**STATE OF HAWAII  
DEPARTMENT OF TRANSPORTATION  
HIGHWAYS DIVISION**

**ADDENDUM NO. 1  
FOR  
KUHIO HIGHWAY RESURFACING  
WAIKAEA BRIDGE TO MAILIHUNA ROAD  
FEDERAL-AID PROJECT NO. NH-056-1(063)  
DISTRICT OF KAWAIHAU  
ISLAND OF KAUAI  
April 21, 2023**

**ADD.20**

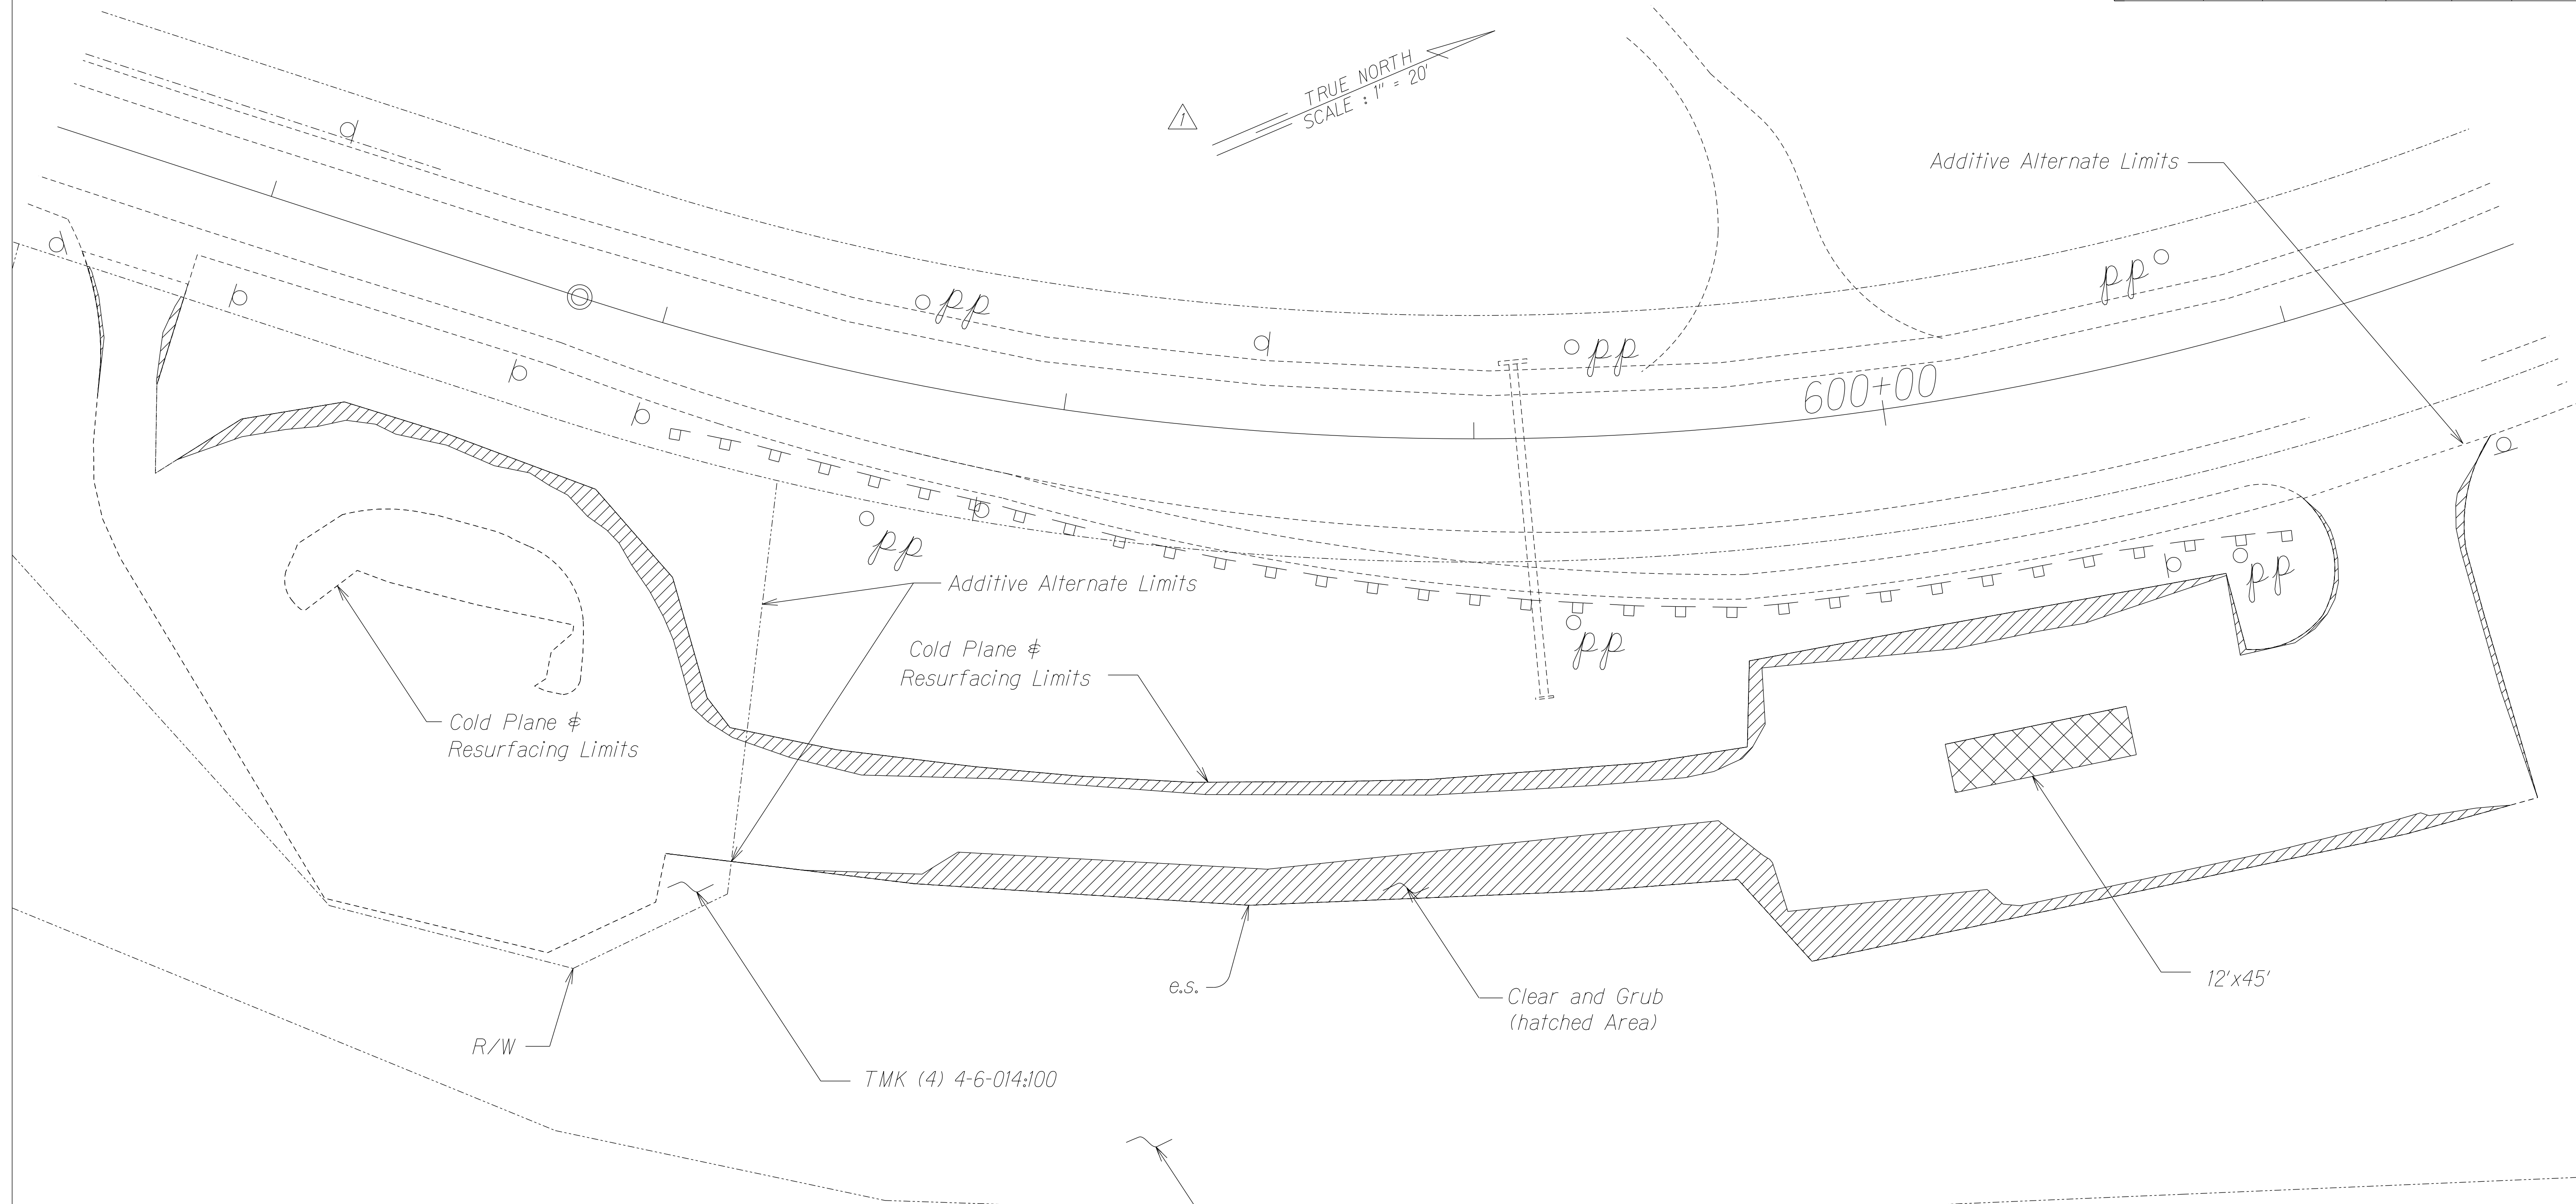
4/13/23	△ - Revision to Graphic Scale and Scale on True North Arrow
DATE	REVISION
STATE OF HAWAII DEPARTMENT OF TRANSPORTATION HIGHWAYS DIVISION	
<b>ROADWAY PLAN</b>	
<i>KUHIO HIGHWAY RESURFACING Waikaea Bridge to Mailihuna Road Federal-Aid Project No. NH-056-110631</i>	
Scale: 1" = 20'	Date: Mar. 2023
SHEET No. 6 OF 6 SHEETS
